## Product Change Notice (PCN)

PCN Number: **PCN-0456246R-01**

Product(s) Affected: **SJ1-2503A**

PREVIOUS CUI DEVICES DETAIL / IMAGE	NEW CUI DEVICES DETAIL / IMAGE

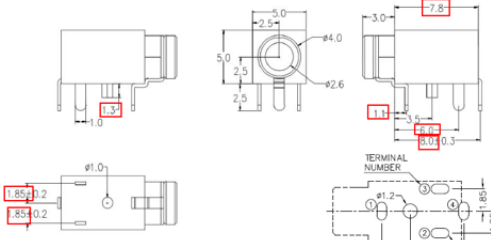
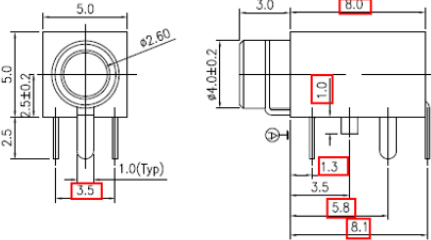
Description of Change: **New Factory Location. Product re-engineered for improved manufacturability and production yield. See image below for reference and check CUI Devices website for updated drawing. Cosmetic differences may be visible and not affect the form fit and function of the product.**

<p>Recommended PCB Layout Top View</p>	 <p>Recommended PCB Layout Top View</p>

PREVIOUS CUI DEVICES DETAIL / IMAGE			NEW CUI DEVICES DETAIL / IMAGE		
DESCRIPTION	MATERIAL	PLATING/COLOR	DESCRIPTION	MATERIAL	PLATING/COLOR
terminal 1	brass	silver	terminal 1	phosphor bronze t=0.30	tin over nickel
terminal 2	copper alloy	silver	terminal 2	phosphor bronze t=0.30	tin over nickel
terminal 3	copper alloy	silver	terminal 3	phosphor bronze t=0.30	tin over nickel
terminal 4	copper alloy	silver	terminal 4	brass t=0.30	tin over nickel
bushing	brass	nickel	bushing	copper alloy	nickel
housing	PBT (UL94V-0)	black	housing	PAB6 (UL94V-0)	black
